Subject

Sliding door control TS 400 – hardware adaption

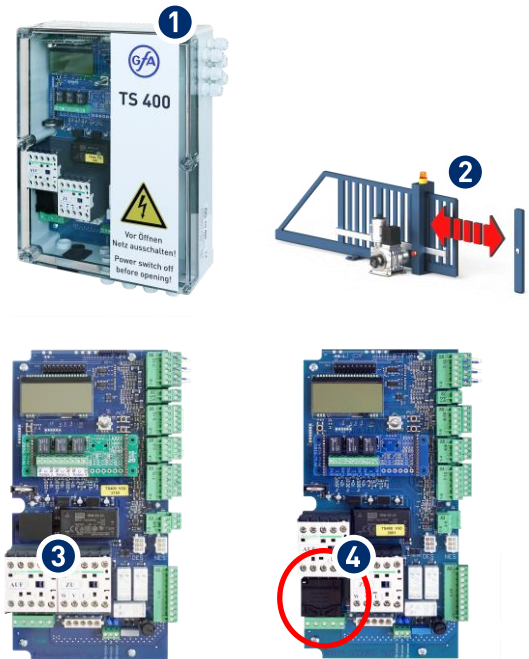
To meet the requirements of EN 12453¹⁾, which is due to be amended, the TS 400 door control (1) for sliding doors (2) has been given a hardware adaption.

An additional contactor is installed for the implementation of an independent shutdown option (3 ⇒ 4).

The functions of TS 400 remain unchanged.
